Attachment 6

PROJECT:
 SINGLE FAMILY RESIDENCE @
 28254 LAURA LA PLANTE
 AGOURA HILLS, CALIFORNIA

A-01.1

SCOPE OF WORK FOR REVISION 3

SHEET TITLE
ROOF PLAN

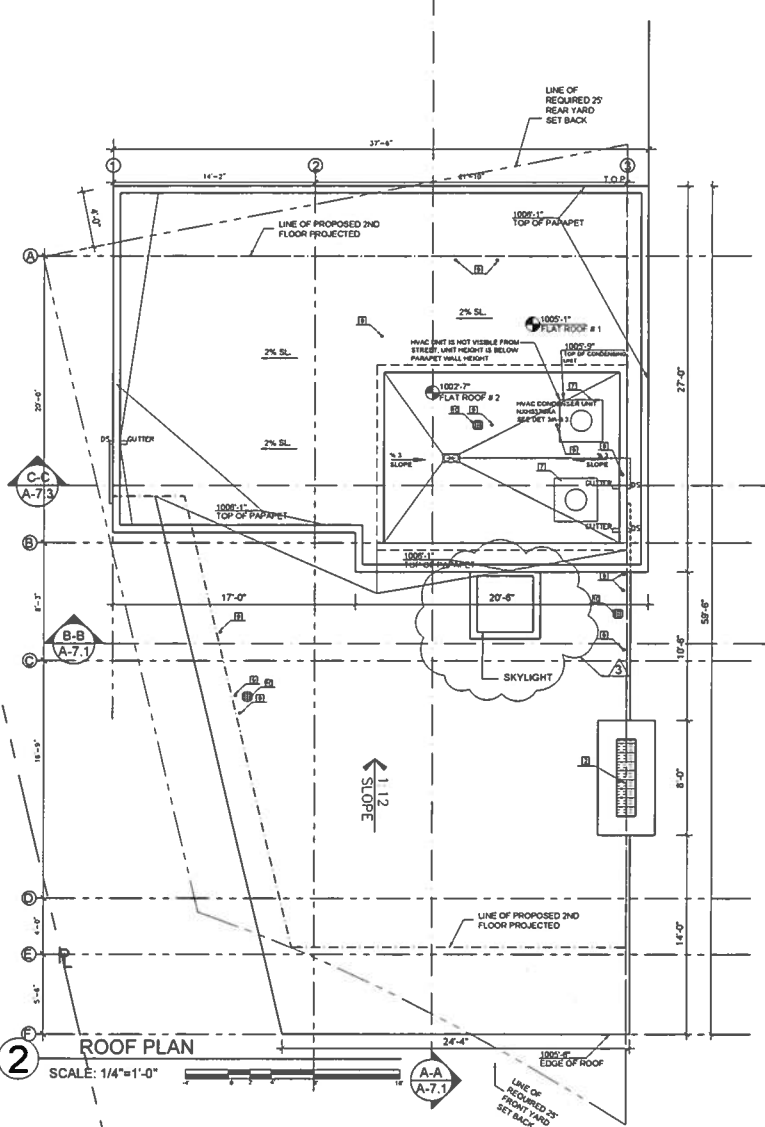
8. skylight added to roof plan over stairway and no roof hatch, access to roof via portable ladder on roof area located at 2nd floor in south of master bed room

SHEET TITLE
SOUTH &
NORTH
ELEVATION

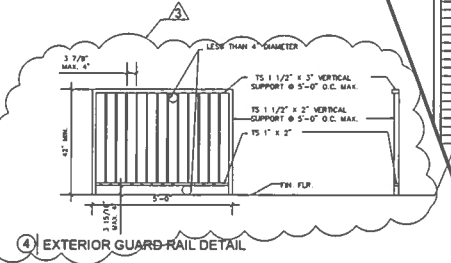
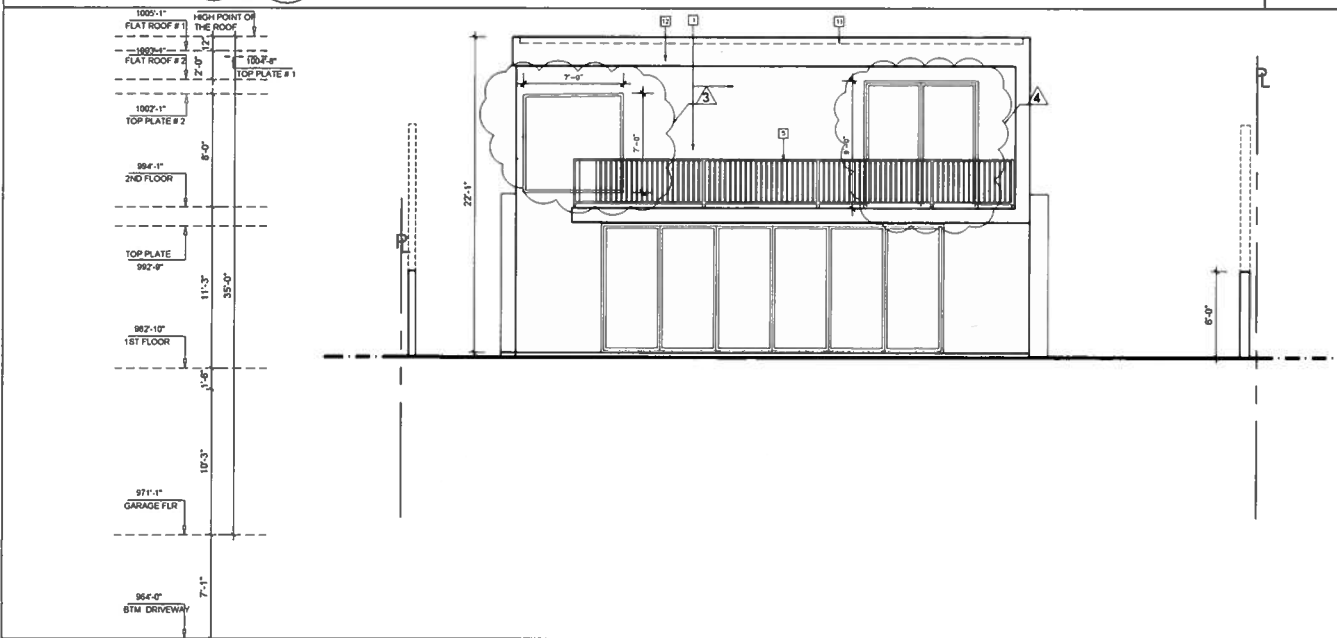
- e. steel mesh around Entry area to be revised to plaster to reduce reflection
 4. front elevation refer to A-06.1
 - a. raising design revision from glass railing to metal railing

- b. window off of living room revised (refer to front elevation @ A-06.1, original window 5'-5" wide X 12'-6" high and proposed window is 5'-0" wide X 10'-0" high on top of 18" stem wall)

- b. 2 windows eliminated
 - c. window added in master bath room water closet area
 7. rear elevation refer to A-06.1
 - a. referred to #2 above
 - b. window in master bath revised (original window 6'-0" wide x 6'-6" high, proposed window 7'-0" wide x 7'-0" high on 24" stem wall picture window "fixed")

SHEET TITLE
 EAST &
 WEST
 ELEVATION

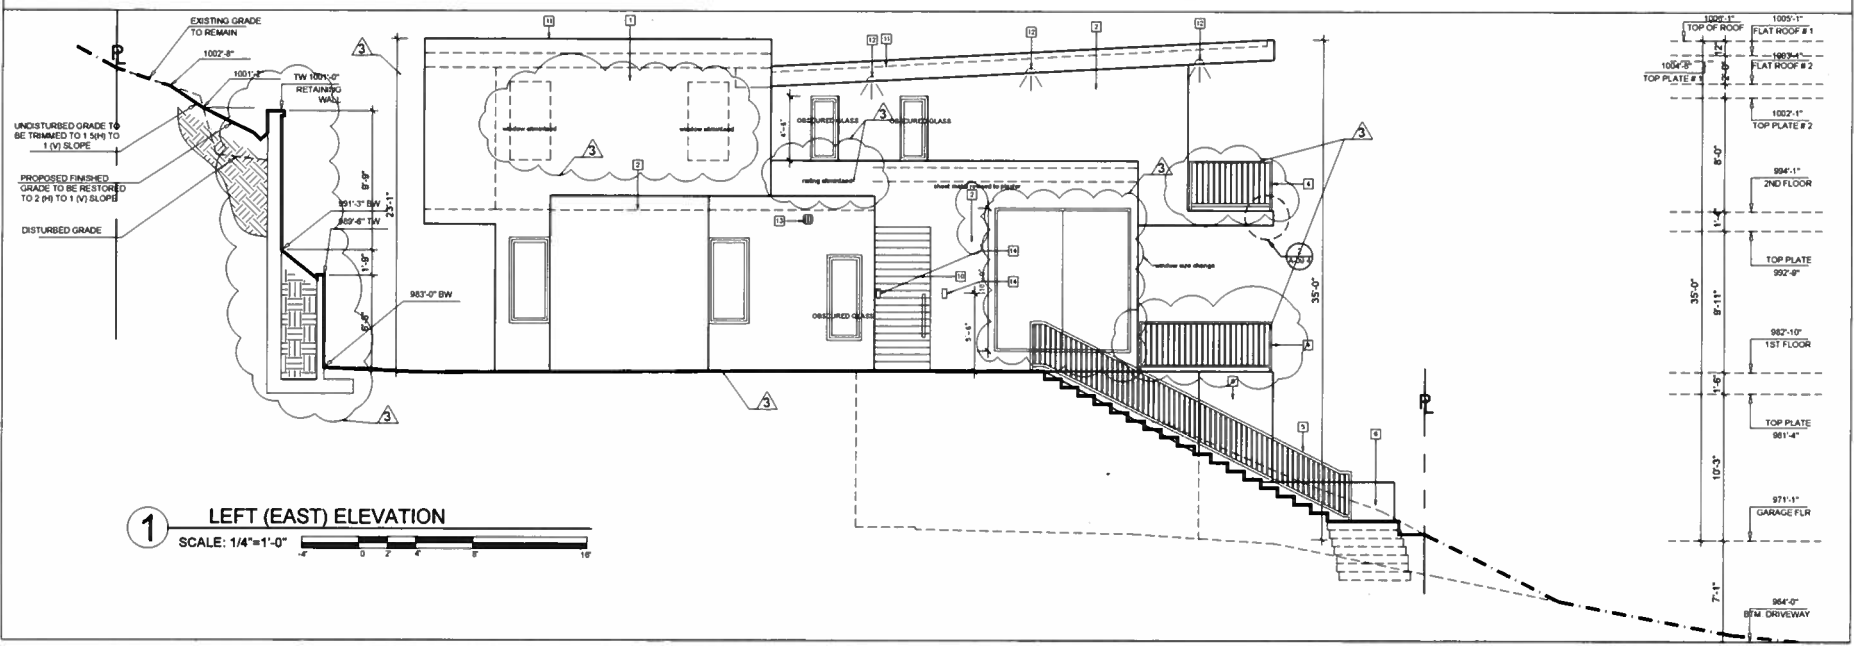
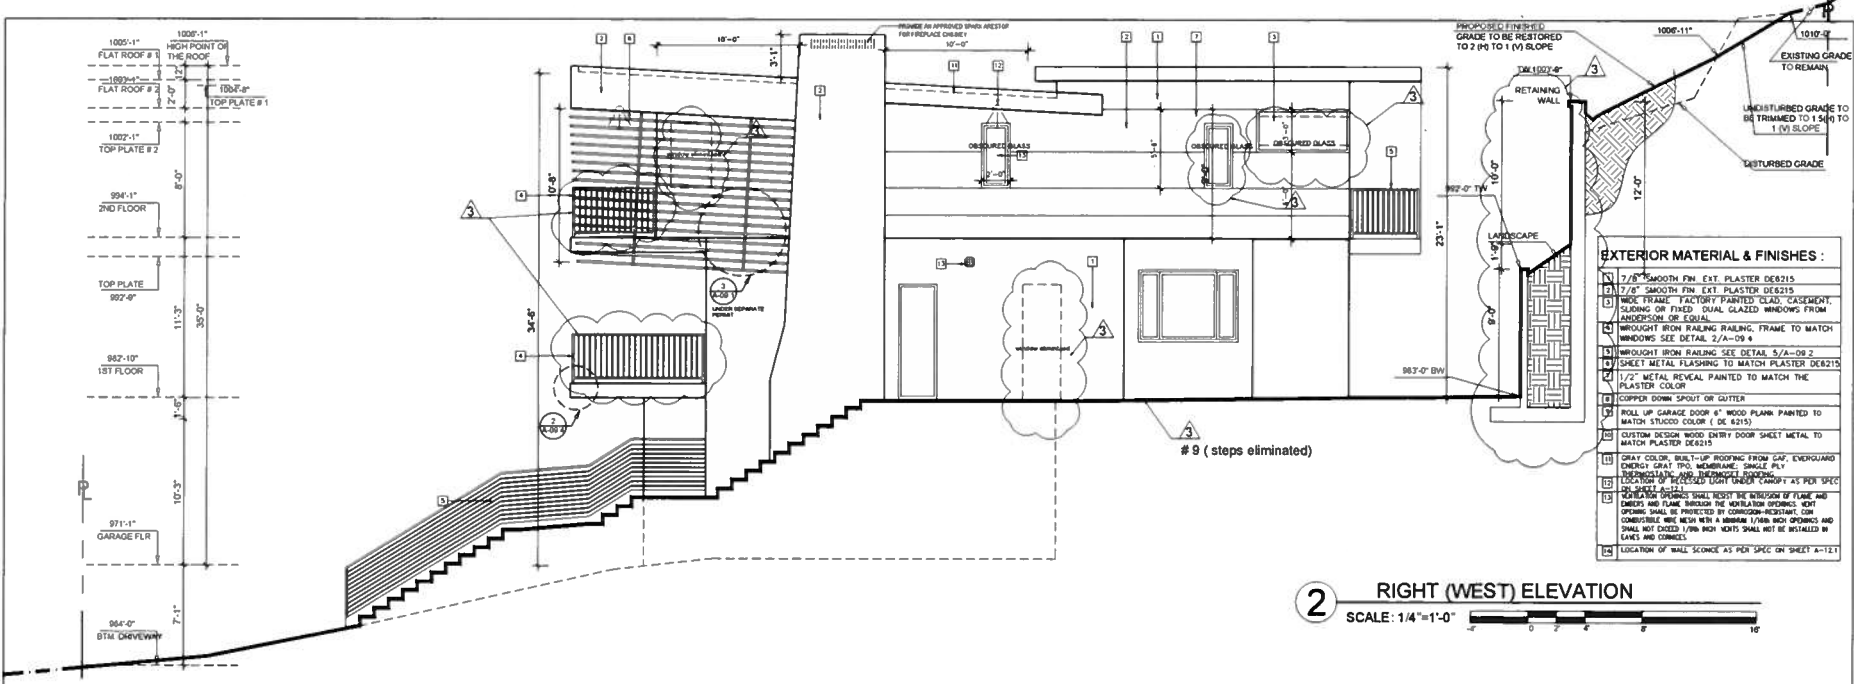
3. N/A
 3. East elevation, refer to A-06.2
 - a. Window size change of living room (refer to east elevations @ A-06.2, original window 12'-6" high by 9'-6" wide, proposed window 10'-0" high x 10'-0" wide on top of 18" stem wall)

- b. Balcony off of master bedroom eliminated to create more privacy
 - c. Window on east side of Master bedroom eliminated to create privacy
 - d. east side wall in balcony #2 to be revised (see #2 above)

6. West elevation refer to A-06.2
 - a. window off of master bath revised (original window 6'-4" wide X 7'-0" high and proposed window 6'-5" wide x 3'-0" high) bottom of window on permit set was 6'-8" bottom of window proposed is at 6'-0"

SHEET TITLE
**SECTION
 A-A LINE OF
 SIGHT
 &
 SECTION B-B**

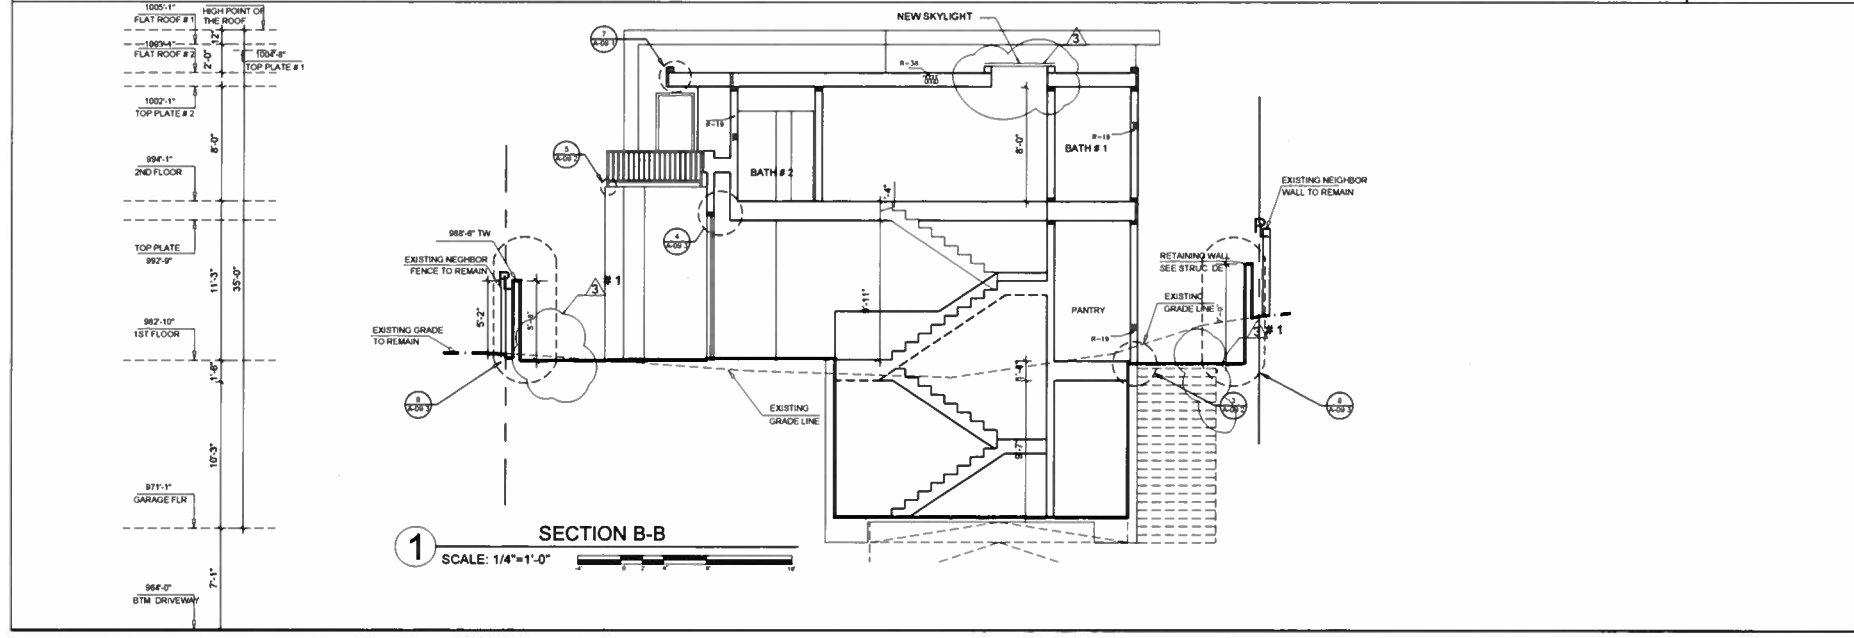
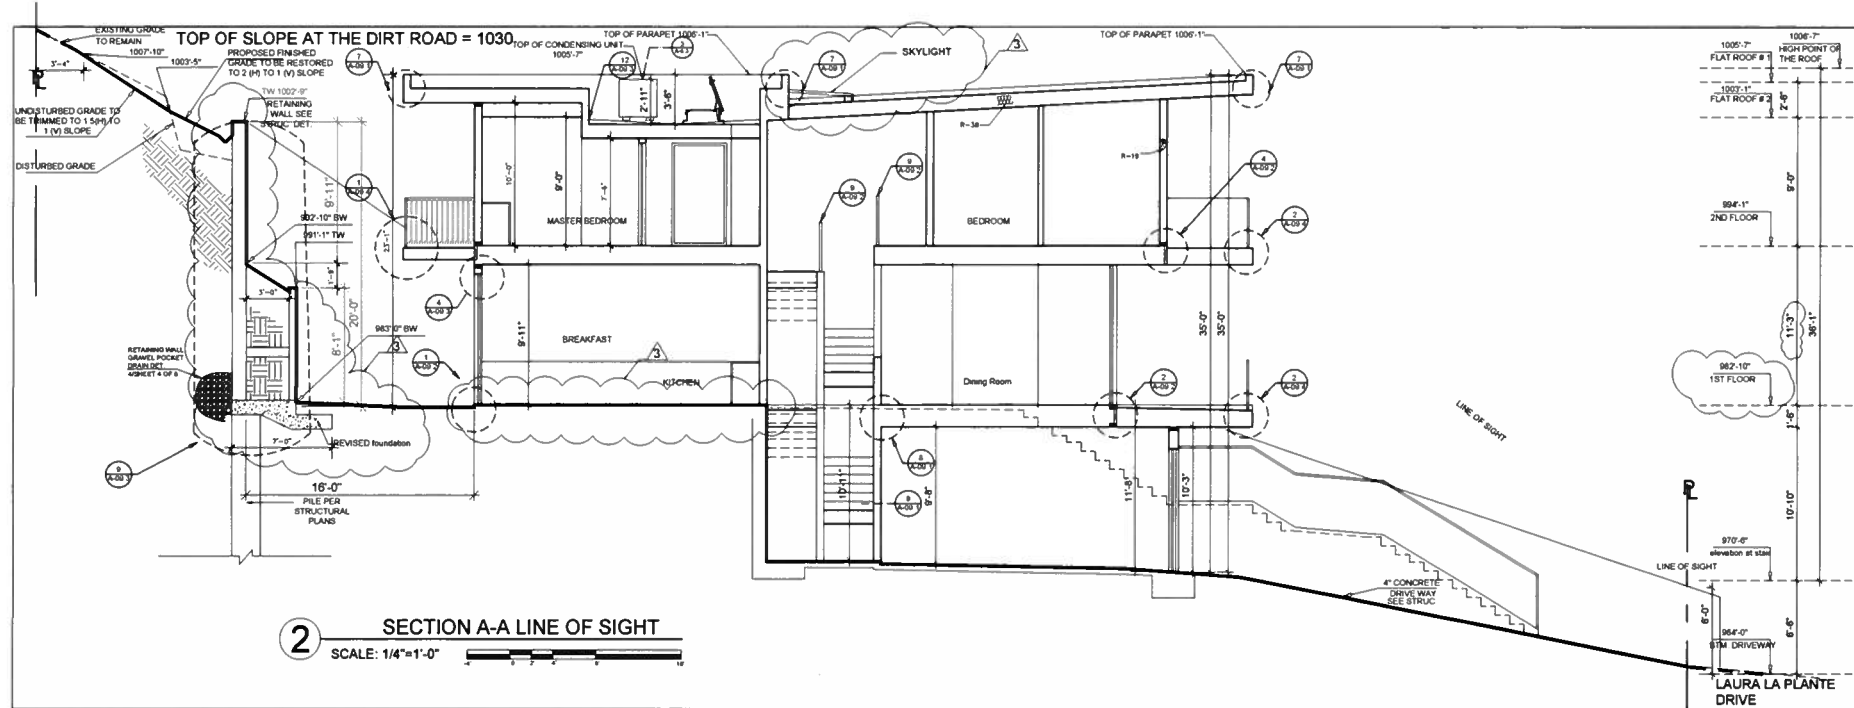
- b. Retaining wall #2 to be 10'-0" height maximum (REFER TO SITE PLAN @ A-02.1 FOR LOCATION, WHERE AS ORIGINALLY WAS APPROVED FOR 9').
 2. Grading and drainage plan on sheet 2 of 8 and East and west elevation on Sheet A-06.2 and sections A-A on sheet A-07.1 demonstrate how back fill with 2 to 1 slope on disturbed slope will meet the existing natural grade and from there a 1.5 to 1 slope will meet the existing natural grade within the said property to demonstrate the method of back fill behind the retaining walls in the back.

SECTION P-P
SCALE: 1/4"=1'-0" **3**

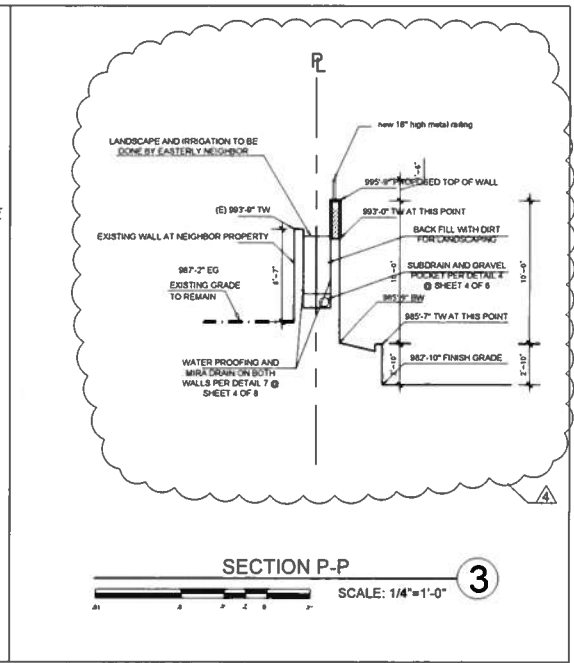
11. revision to entry door to add the proposed wall as shown to section E-E at A-07.3 and cross section P-P at A-07.3 (max. height = 10'-0" and 18" railing on top of the wall to Screen without intractiveness of a solid wall

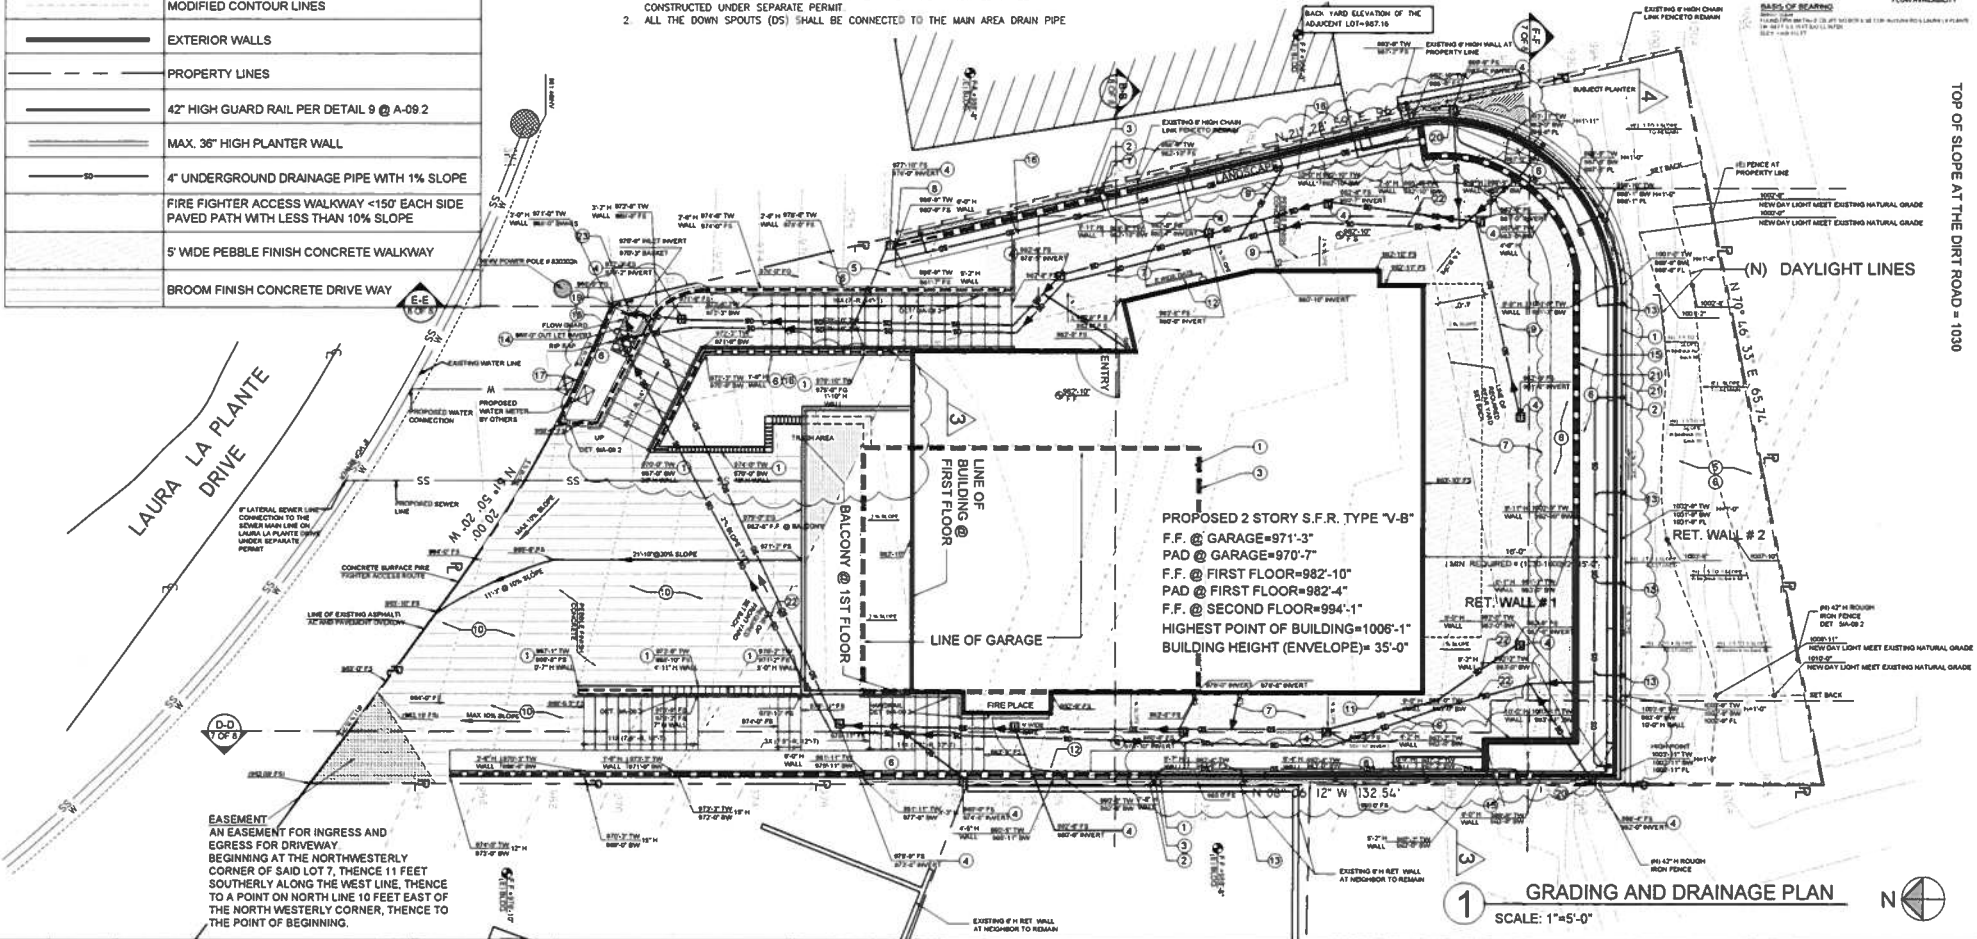
- Scope of work for revision:
1. Retaining wall height in back:
 - a. Retaining wall to be 9'-2" height maximum (REFER TO SITE PLAN @ A-02.1 FOR LOCATION, WHERE AS ORIGINALLY WAS APPROVED FOR 8').
